Product Change Notice

New version of Rx-IC and lead frame

AFBR-59F2Z

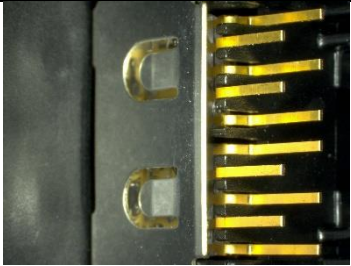
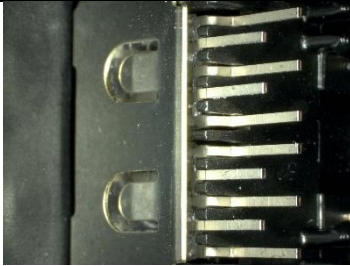
- Design improvement for lead frame
- Change lead frame plating from NiAu-spot Ag to NiPdAu
- New version of Rx-IC
- Update of datasheet
- Upgrade of mould compound

old	new						
Visual appearance								
Plating structure	<table border="1" style="margin-left: auto; margin-right: auto;"> <tr><td>Ag-spot</td></tr> <tr><td>Au</td></tr> <tr><td>Ni</td></tr> </table>	Ag-spot	Au	Ni	<table border="1" style="margin-left: auto; margin-right: auto;"> <tr><td>Au</td></tr> <tr><td>Pd</td></tr> <tr><td>Ni</td></tr> </table>	Au	Pd	Ni
Ag-spot								
Au								
Ni								
Au								
Pd								
Ni

Internal lead frame design changed to improve the heat conductance using both GND pins and harmonize assembly process. The thickness of the lead frame remains unchanged.
 Change of lead frame plating to streamline production and increase availability.
